FINAL ENVIRONMENTAL ASSESSMENT

(File No. 200500656)
Applicant: City View at Riverwalk, LLC

PROPOSED PRIVATE MARINA, DREDGING, BANK STABILIZATION,
AND STORMWATER OUTFALL AT MILE 647.2, LEFT BANK, TENNESSEE RIVER (FORT
LOUDOUN LAKE), IN KNOXVILLE, KNOX COUNTY, TENNESSEE, USGS KNOXVILLE-TN 7.5
MINUTE SERIES QUADRANGLE MAP, LAT 35° 56' 43", LON 83° 55' 28"

29 September 2006

EXHIBIT A
FILE NO. 200500656
P.N. NO. 05-18

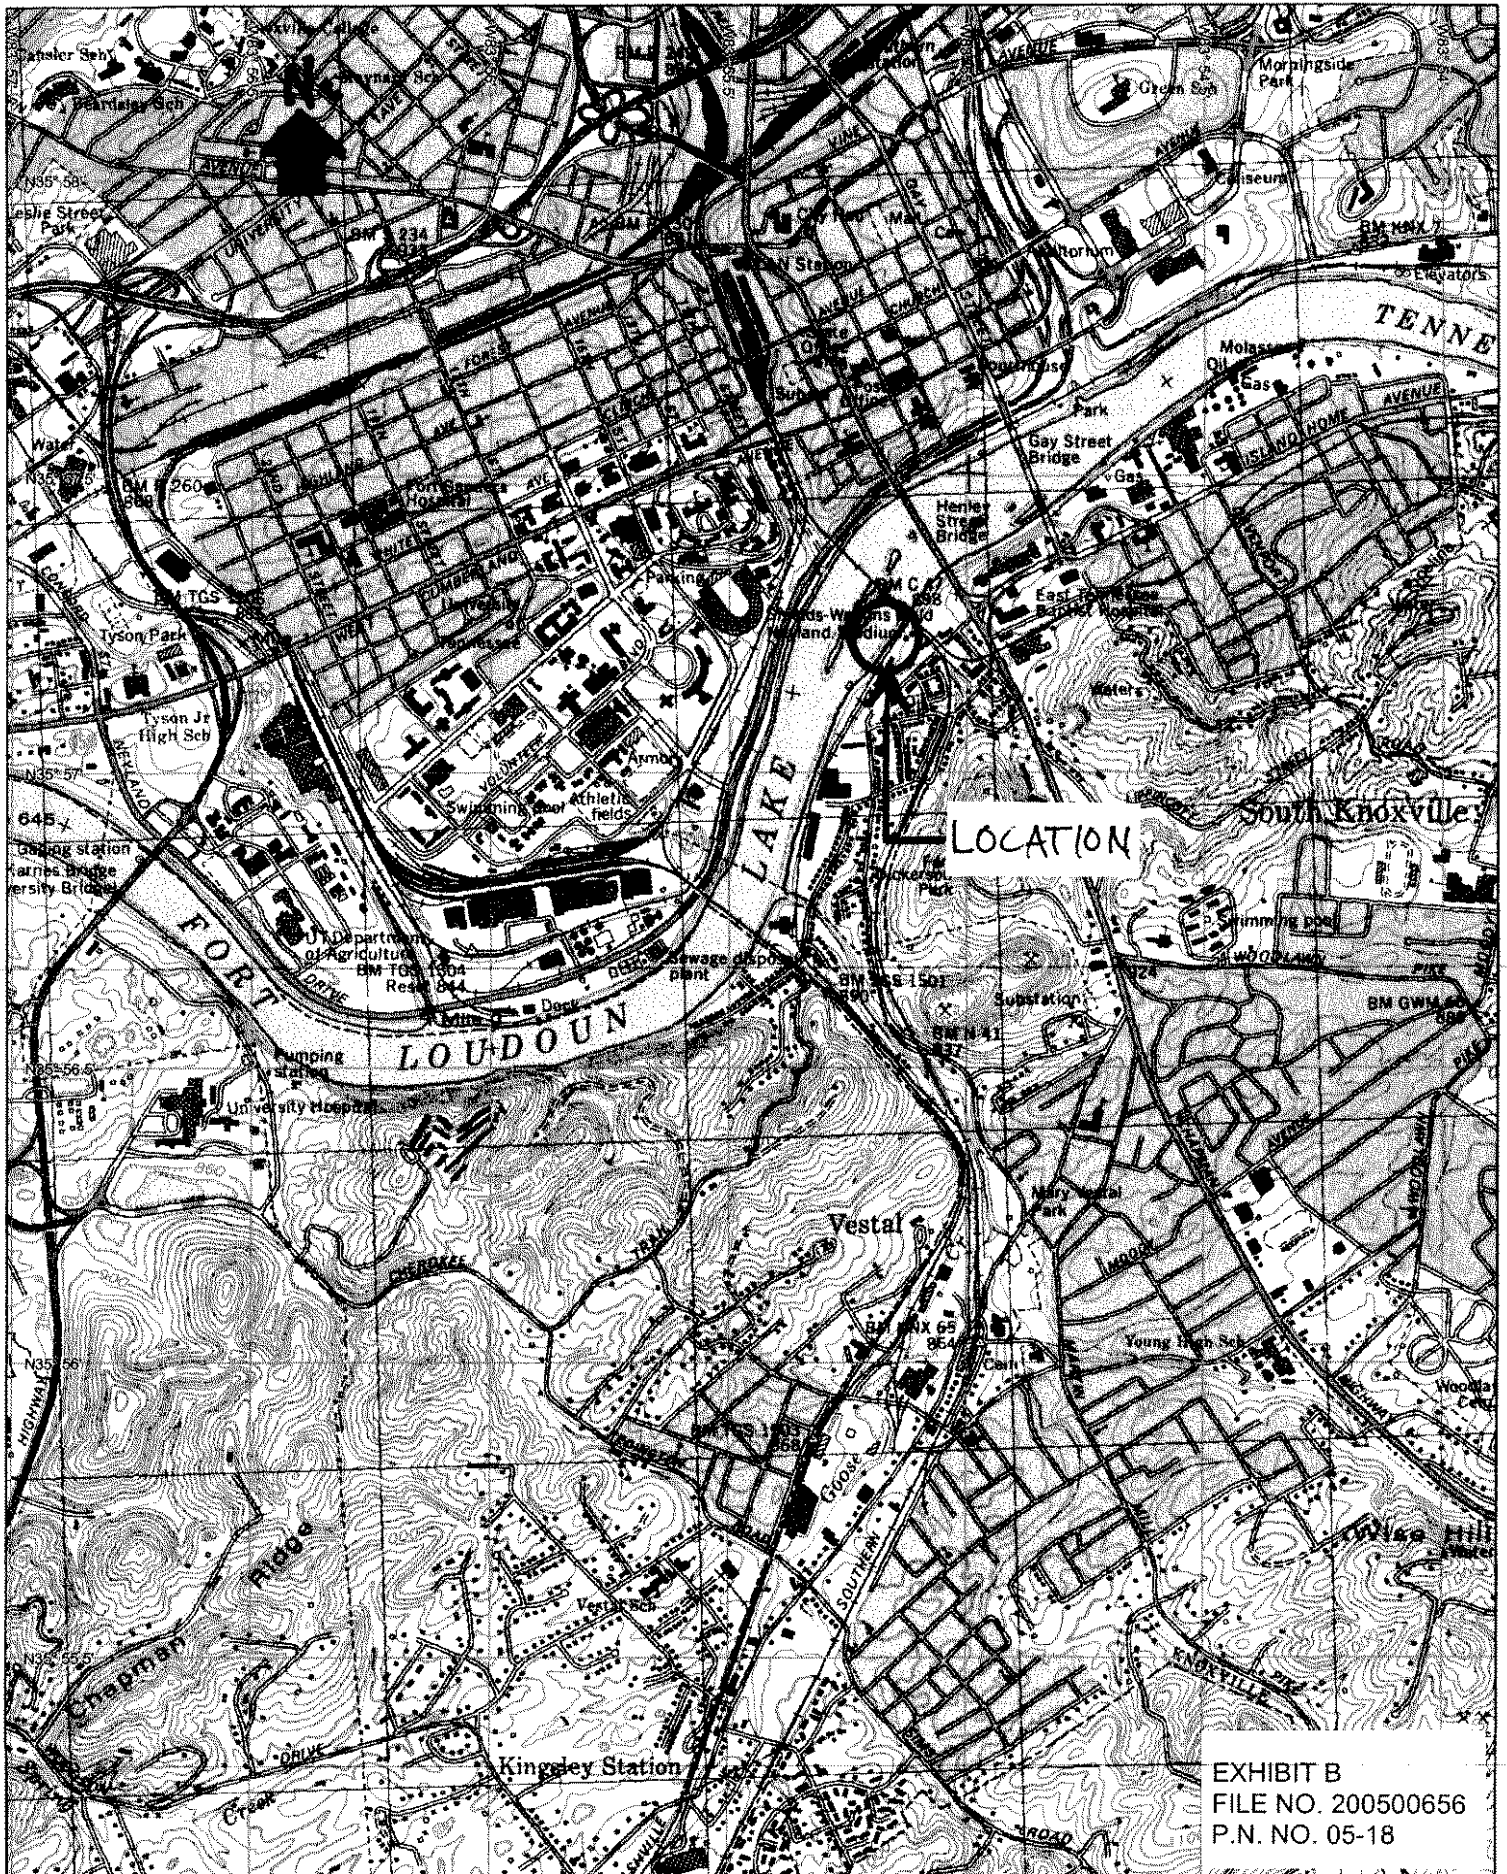
1. On the upper end, the last row of slips we said that the outer four slips should be removed from the plans because they interfere with the Knoxville Rowing course which is already permitted.
2. The next set of slips should have the outer two slips removed also as to not to interfere with the rowing course.
3. I also feel that the developers should be made aware that every time the course is in use for races and practicing that no boats will be allowed to cross the course. More than likely there will be a safety zone put around the course. So anyone wanting to get their boat out will have to know the schedules of the events and plan accordingly.
4. With this marina being so close to this racing course safety will be a top priority!
5. Also there will be no "No Wake" zones along the main channel unless deemed so by the U.S. Coast Guard. This will probably apply during rowing events.

- On the upper end, the outer four slips of the last row of slips should be removed from the plans because they interfere with the Knoxville Rowing course which is already permitted.
- The next set of slips should have the outer two slips removed also as to not to interfere with the rowing course.
- The applicant should be made aware that every time the course is in use for races and practicing that no boats will be allowed to cross the course. More than likely there will be a safety zone put around the course. So anyone wanting to get their boat out will have to know the schedules of the events and plan accordingly.
- With this marina being so close to this racing course safety will be a top priority.
- There will be no "No Wake" zones along the main channel unless deemed so by the U.S. Coast Guard. This will probably apply during rowing events.

OVERALL SITE PLAN

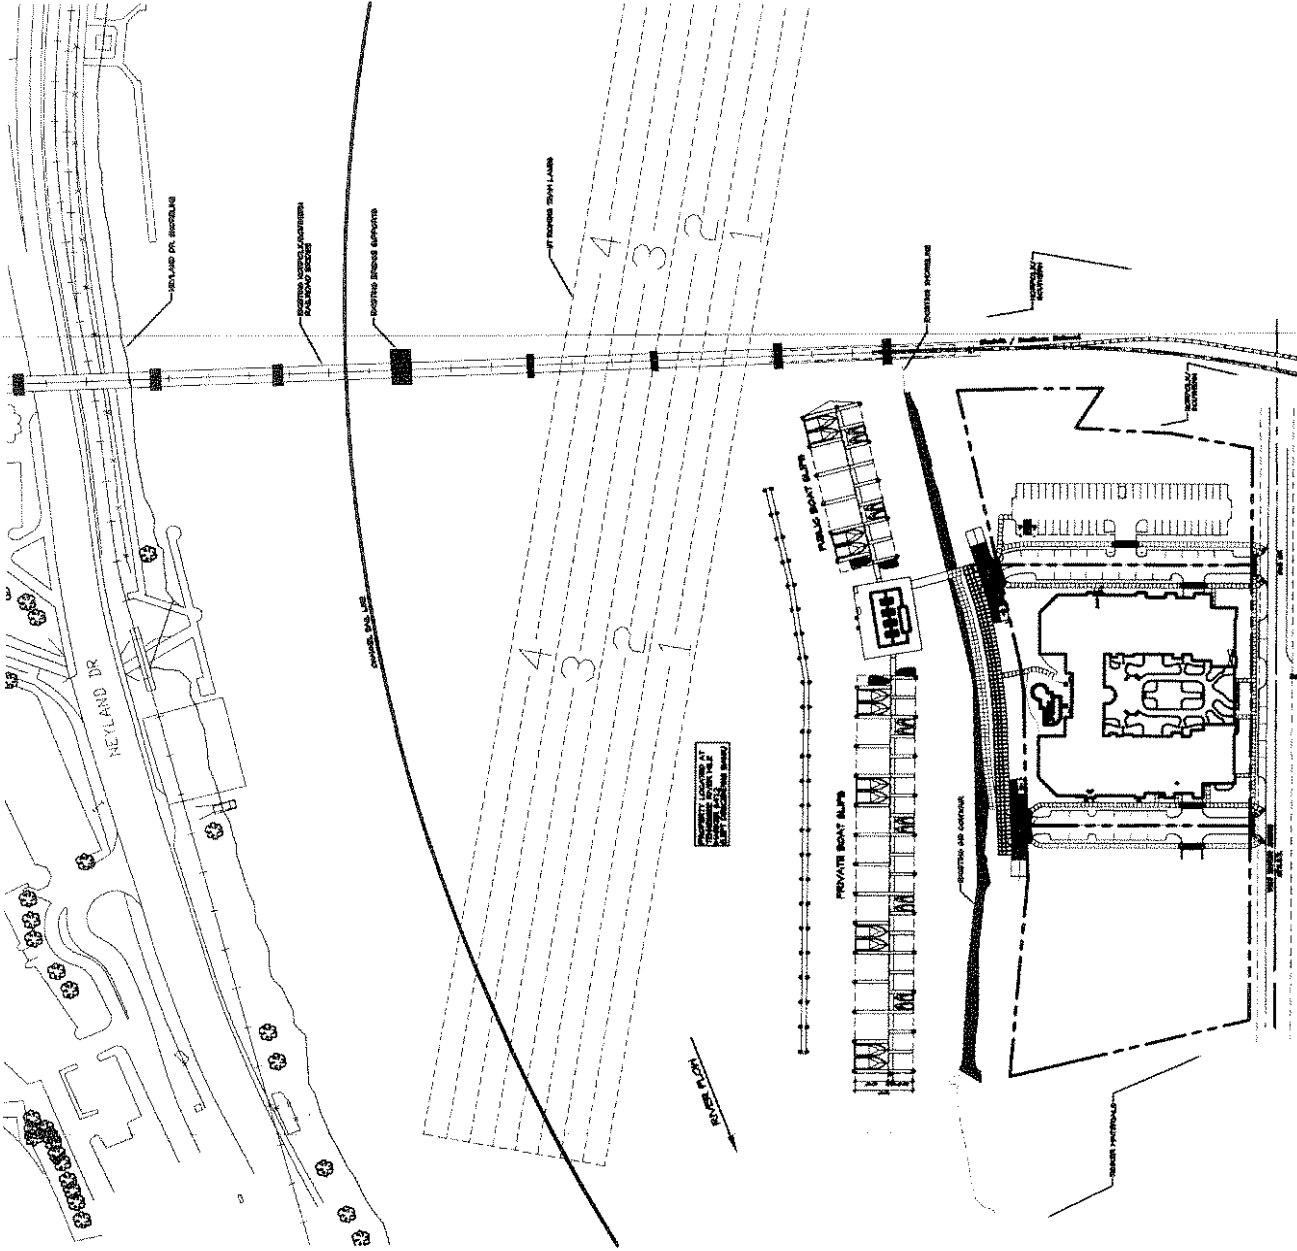
Any vessel departing upstream from Rinker's load-in/load-out facility or fleeing from a temporary tie-up at the concrete dock would be in conflict with the downstream slips as shown on City View's drawings (see Drawing C1.4). This would be due to maneuvering needs as the vessels enter the current flows of the river.

Rinker's facility. We believe City View's plans should be modified at the downstream end to prevent interference with Rinker's use of its property. We also believe there should be an indication of steps to be taken to prevent possible trespass onto Rinker's property by City View's clients.

Rinker, who owns a barge terminal immediately downstream of City View property, has expressed concerns that boaters may interfere with its operation, and more importantly, that portions of the marina appear to encroach into their terminal. In addition, Rinker is concerned about possible trespassing issues. In response to these concerns, City View has offered to identify, notify, and post the limits of the marina for all vessel owners and users. This limit will clearly indicate Rinker's property. A chain link fence currently in place at the common property line with Rinker will be maintained during construction and not be disturbed by the project. No trespassing signs can be installed if Rinker so requests. City View will furnish Rinker contact information and pledges to maintain an open communication policy and remedy any concerns and complaints. Finally, City View has reduced the number of slips (204 to 91) and provided a property map to show that all work would be circumscribed to its boundaries.
